# 1989 - 1990 Corvette: Service Bulletin: Convertible: Mounting Bracket Rattle at Rear of Hardtop

**Number:** 90-203-10

**Subject:** Mounting Bracket Rattle at Rear of Hardtop

**Model Year:** 1989-1990 Y Car Convertible

**CORVETTE HARDTOP**  
**BRACKET REAR PIN MOUNTING R/L**  
 ( SERVICE PROCEDURE )

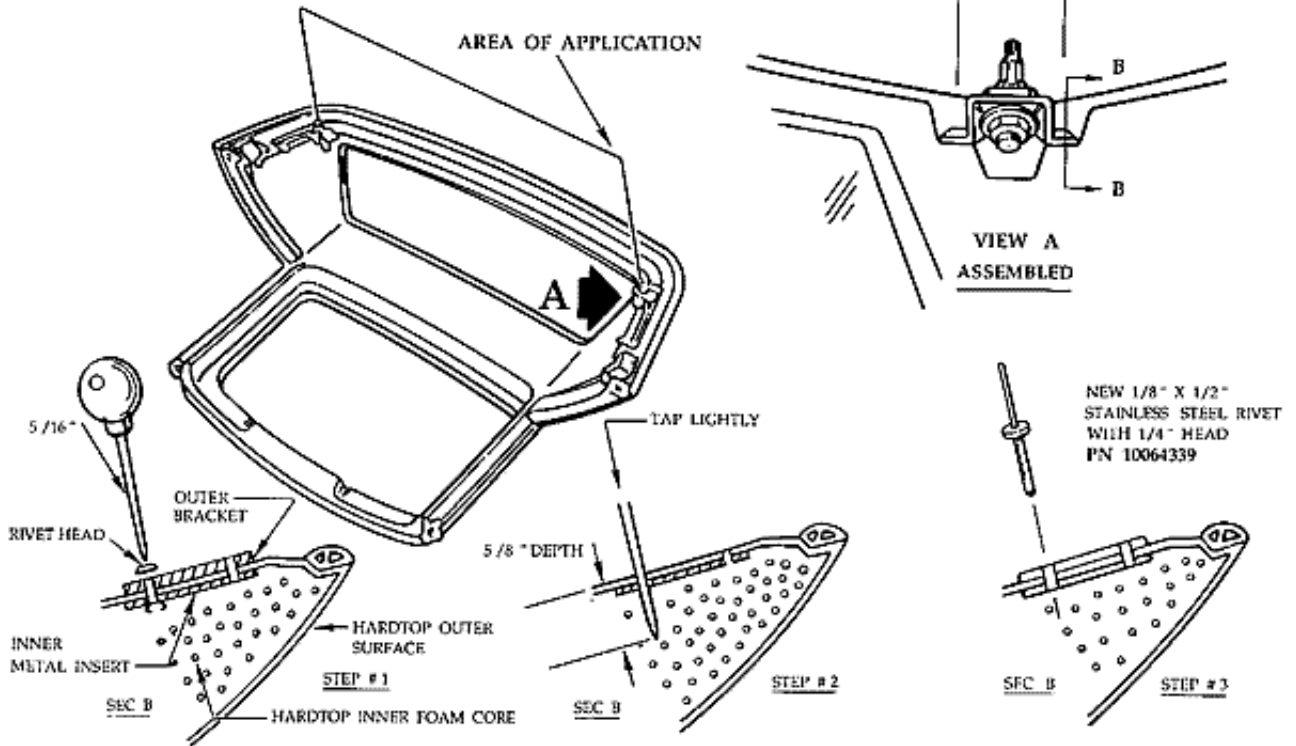
Some 1989 and early 1990 Chevrolet Corvettes (before VIN 106253) equipped with the convertible hardtop option (CC2) may exhibit a rattle at the rear of the hardtop caused by loose hardtop mounting brackets.

Some of these brackets were mounted with rivets which were not long enough to provide enough retention to prevent the rattle.

- STEP #1 DRILL OFF RIVET HEADS, USING A 5/16" DRILL BIT, AND REMOVE BRACKET. (4 RIVETS PER ASM.)
- STEP #2 TAP PREVIOUS RIVET BODIES AND MANDREL 5/8" DOWN INTO HARDTOP INNER FOAM CORE AREA. (4 RIVETS)
- STEP #3 REPOSITION BRACKET AND RE-ATTACH USING NEW RIVET (PN 10064339)
